Brewery Yard, Central Park Sydney

Response to Submissions: City of Sydney

Response to City of Sydney Submission

These notes are prepared in response to comments made by the City of Sydney in relation to SSD-9374 and it should be read in conjunction with related correspondence by Ethos Urban and associated consultants.

CS05

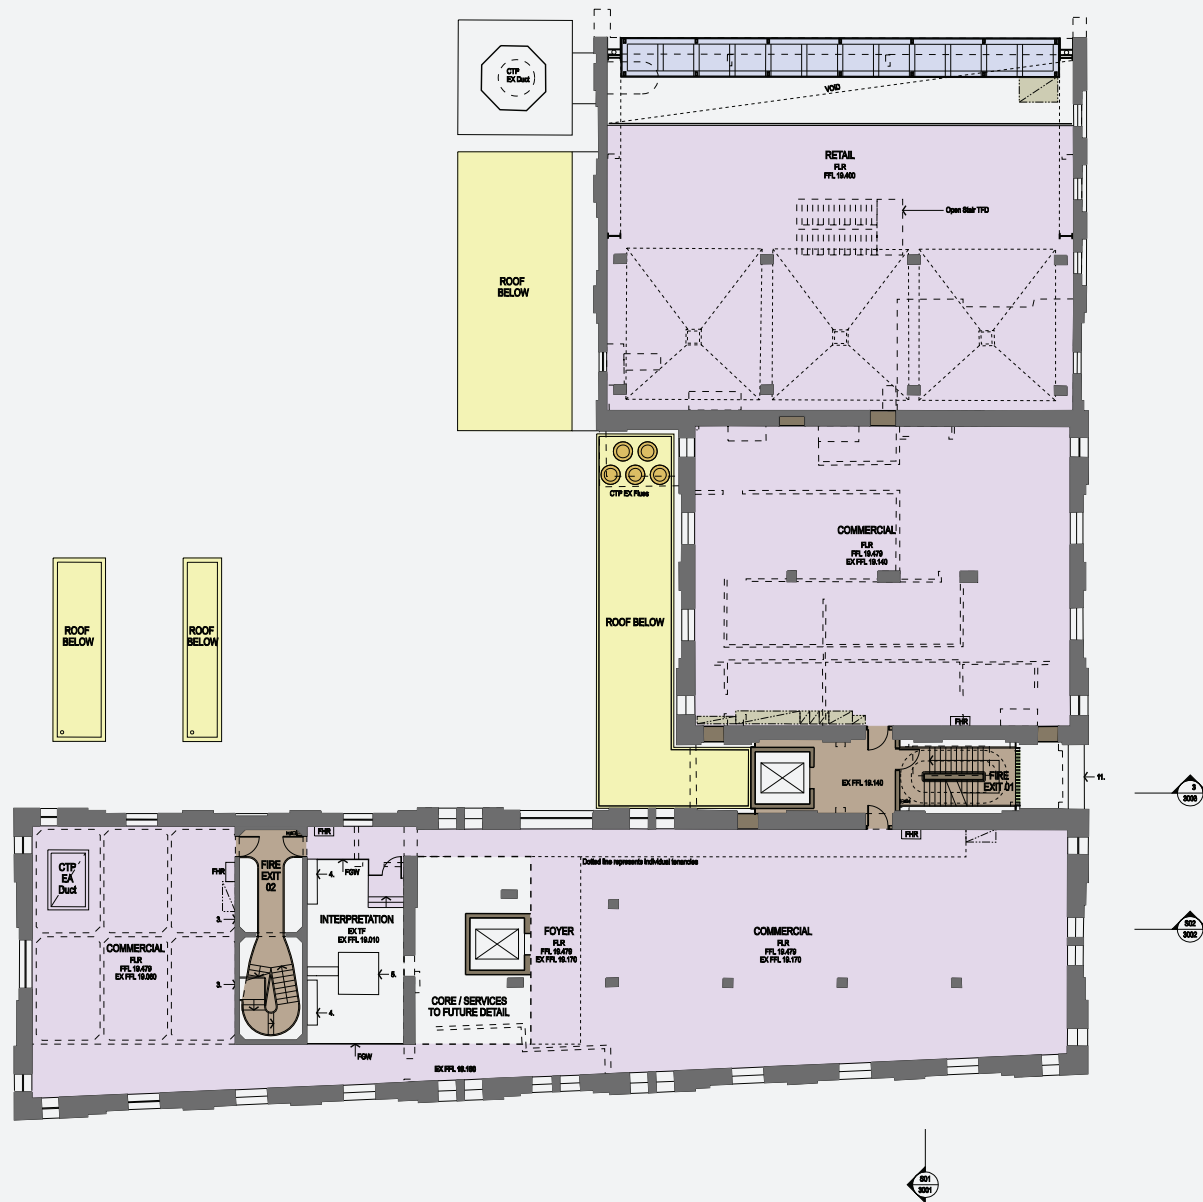
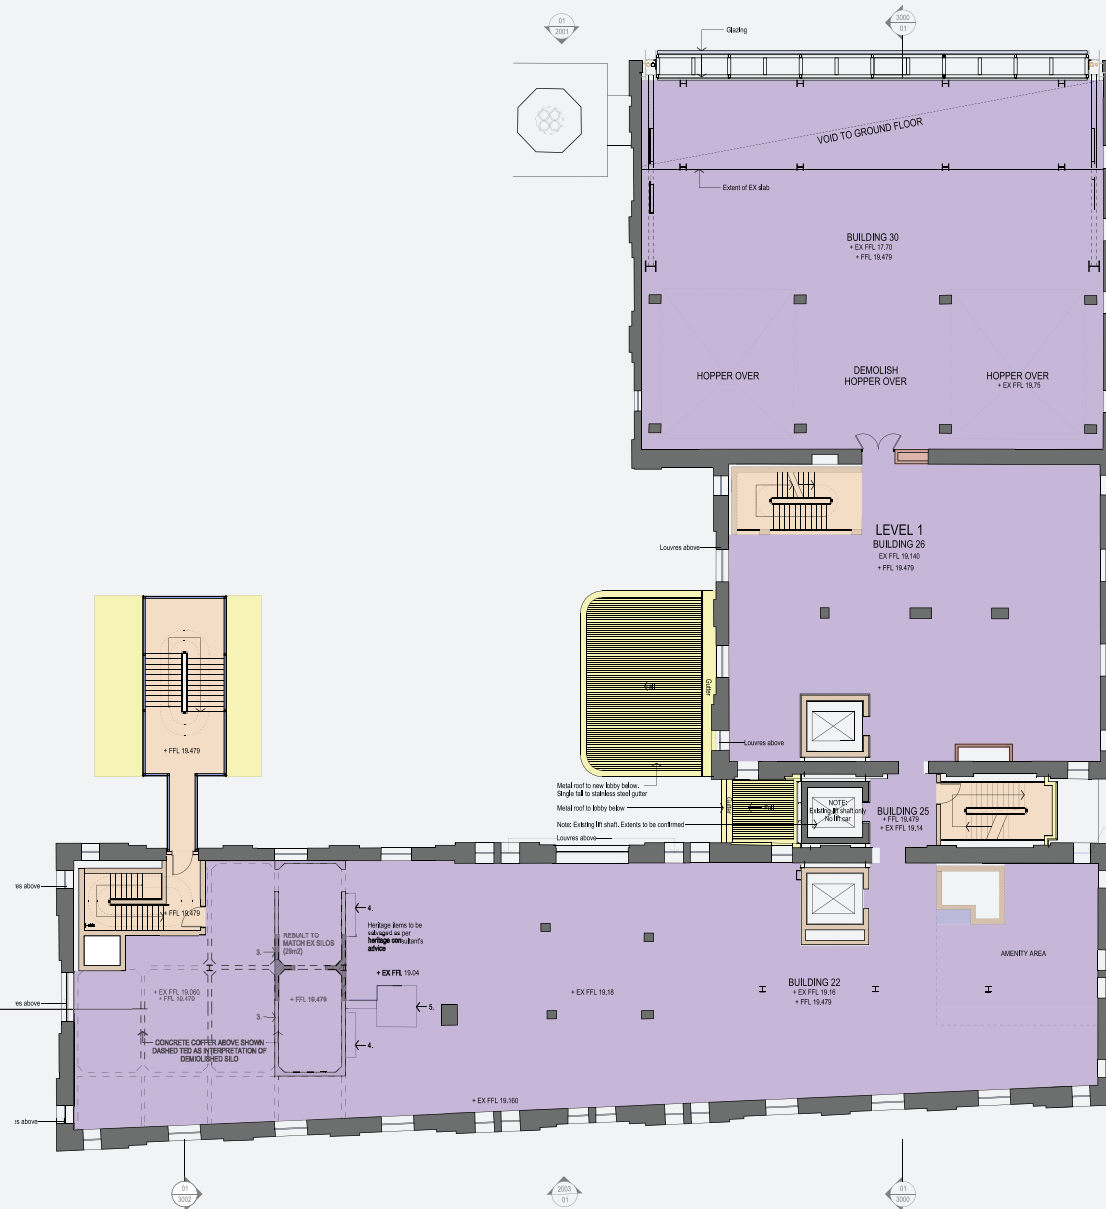
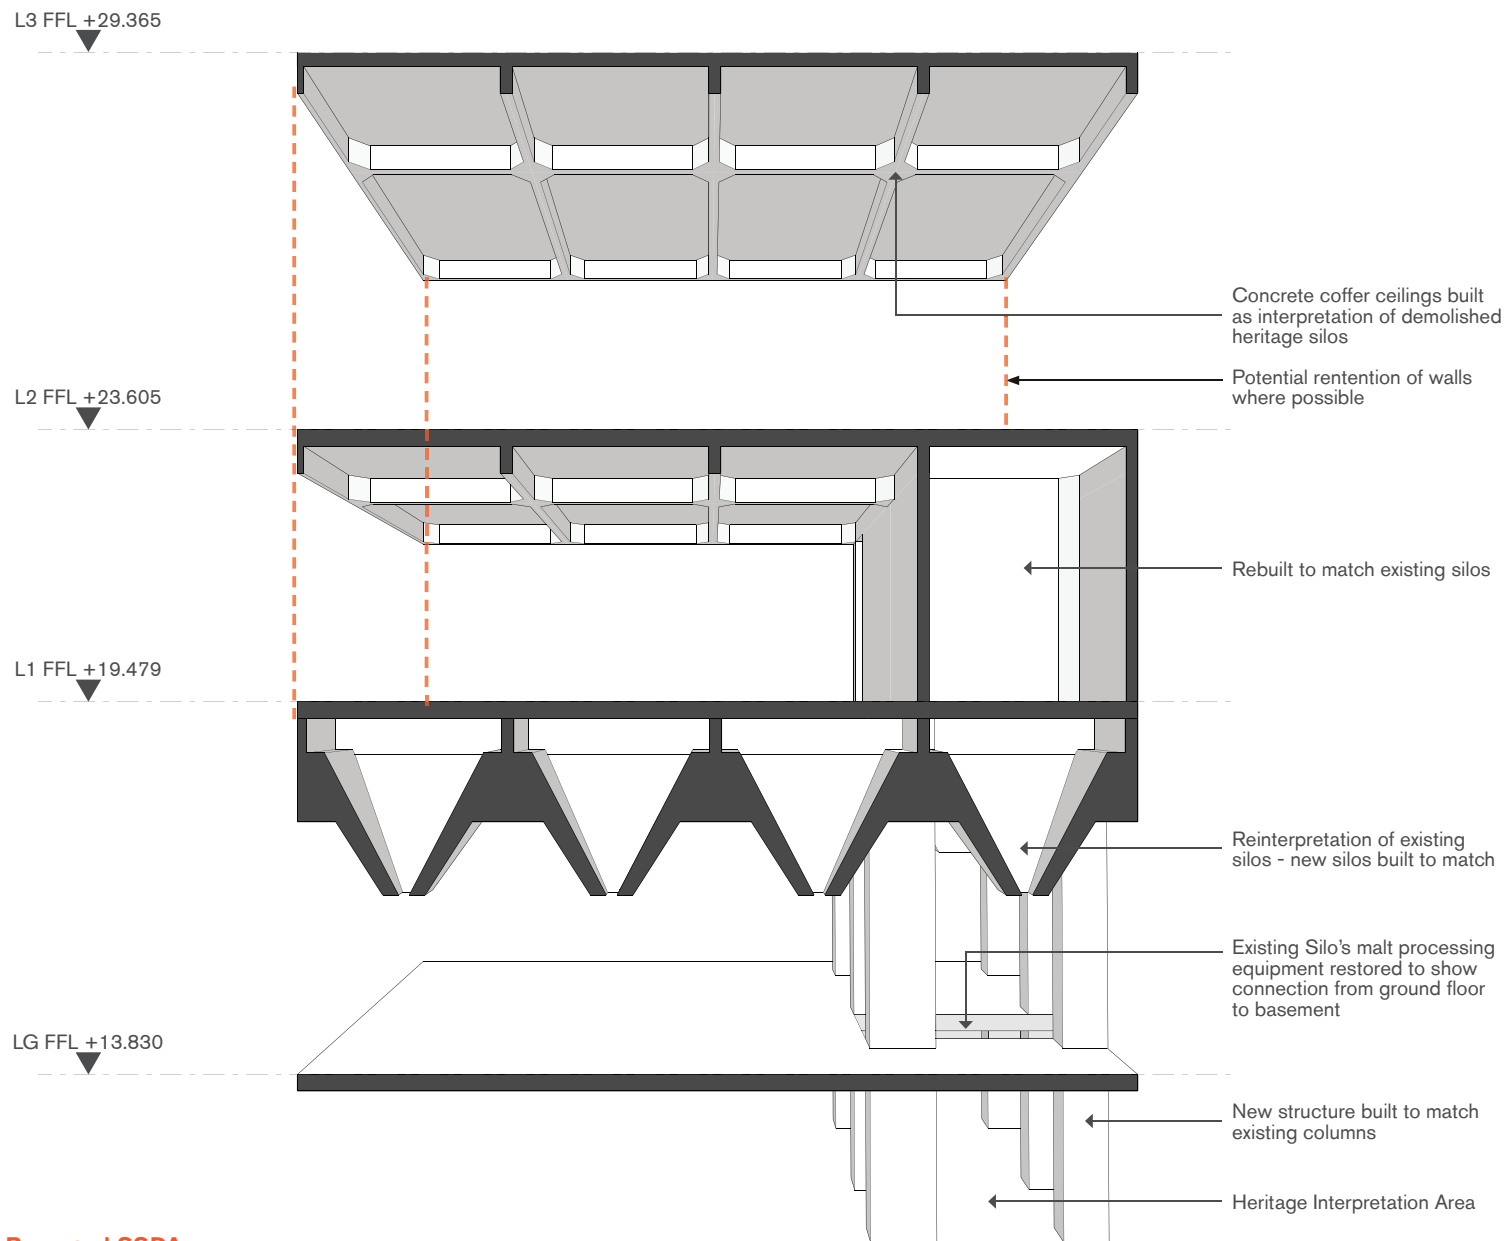
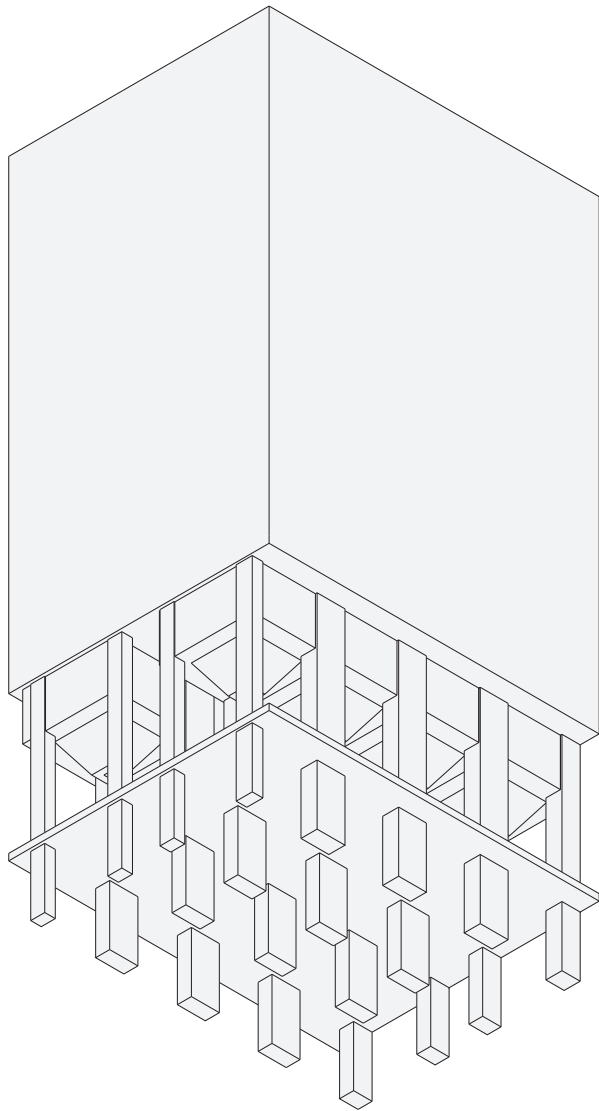
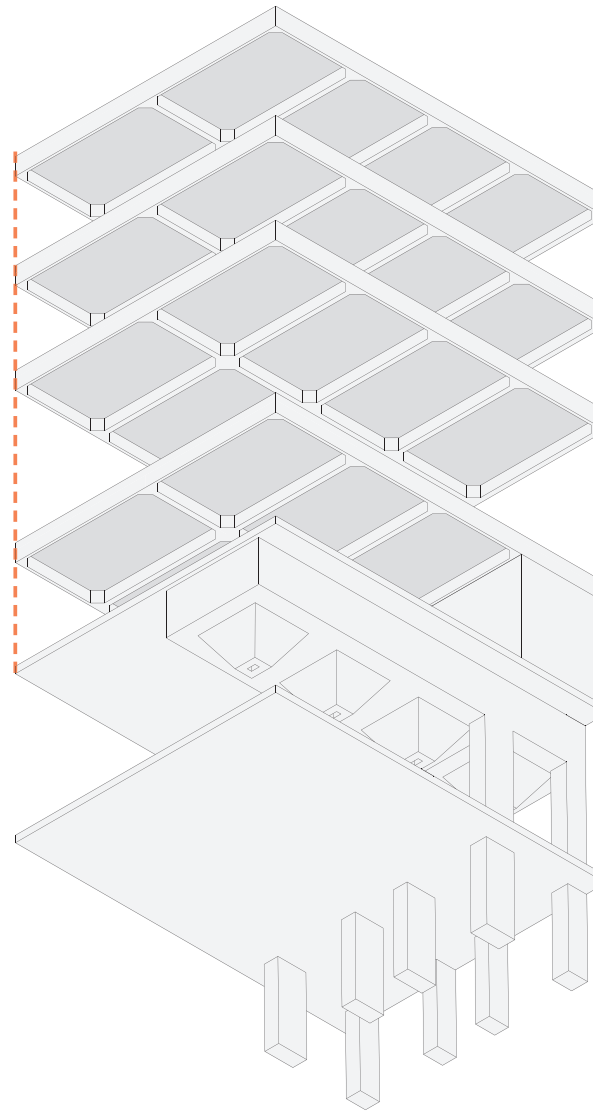
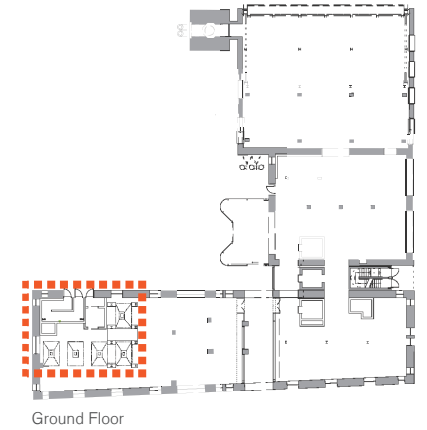
Building 23 Silo removal

Design development as well as structural and construction investigations have revealed that it is extremely challenging to partially retain the silos as proposed in the previously approved SSDA. A number of options were reviewed including the previously approved scheme, which was not achievable from a structural perspective, buildability and earthquake standards.

As such it has been proposed to retain where possible and reconstruct where this is viable. Where the concrete silos engage with the existing brickwork of the external walls (and without clashing with windows) it is proposed they are retained.

As an interpretive strategy it is proposed that the base of the hoppers (see right) and wall are reconstructed, as with the eastern most pair on Level 01. This enables the most significant equipment to be understood. In addition to this, the new concrete coffer ceilings will provide a strong interpretation in the scale and positioning of the silos level by level. The new coffer ceilings and any of the retained silo fabric will complement each other and assist in reading the heritage significance of building 23.

CS06

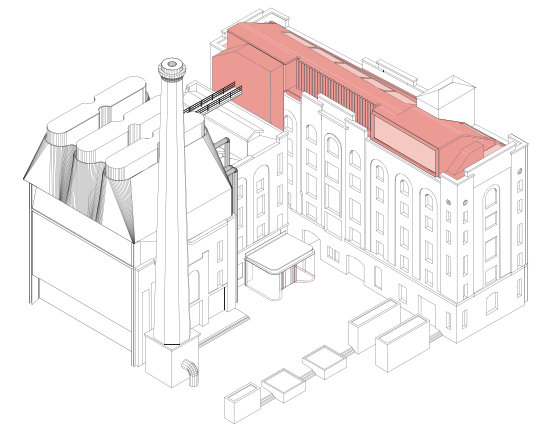
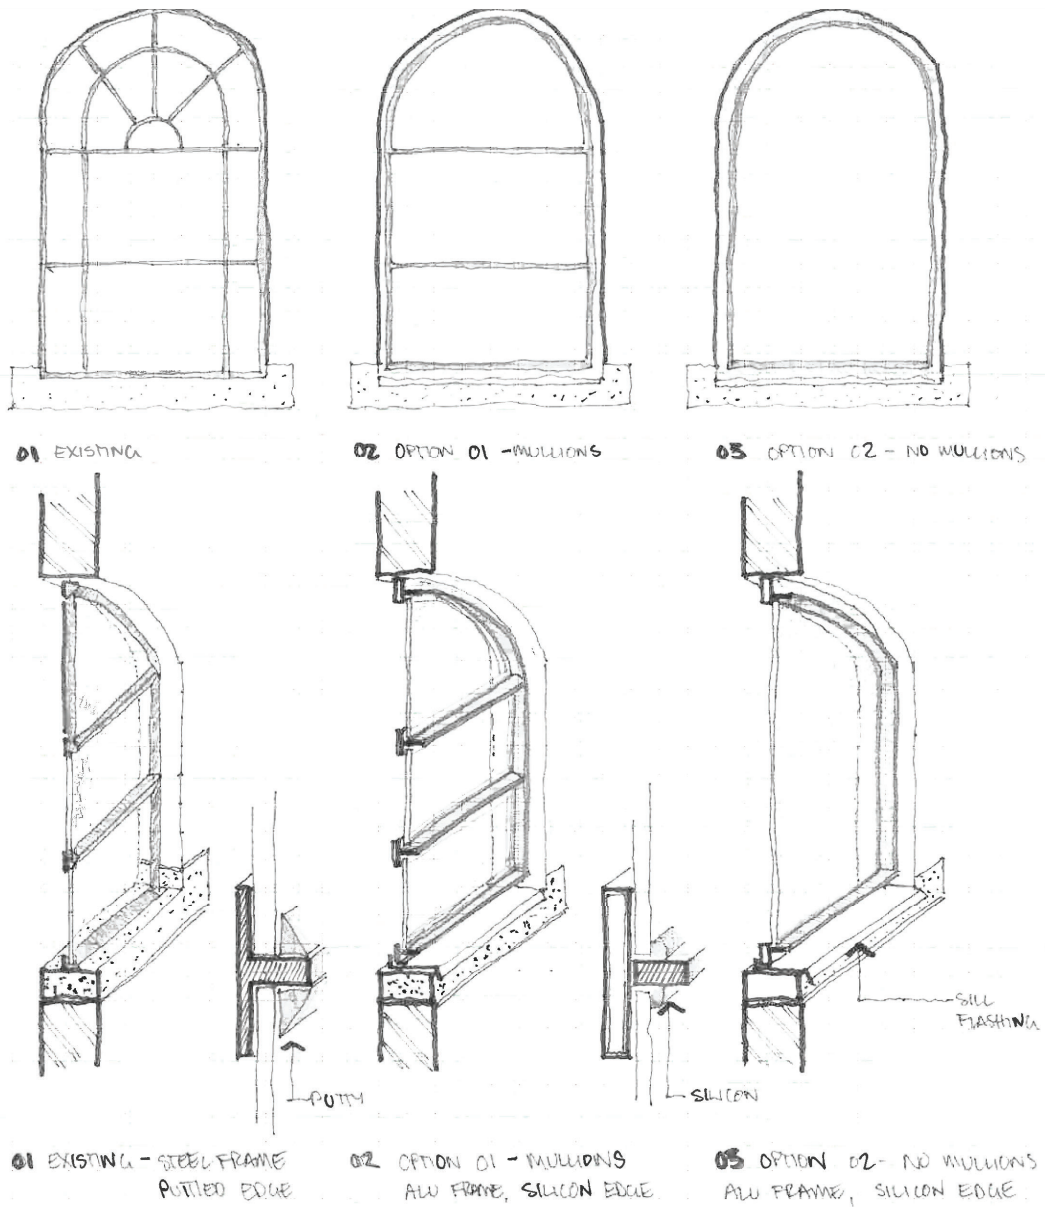
Preliminary investigations has revealed that a large number of the existing windows are damaged beyond repair or refurbishment. As part of the next stage a revised audit of the existing windows will be completed confirming the current status of this program.

It is intended that new windows will be contemporary bespoke aluminium window frames with high performance glazing to improve the environmental performance of the building as a whole.

The new glazing is defined by a shadow detail separating the window from the surrounding brickwork and an expressed fine aluminium edge, referring to the existing steel window system.
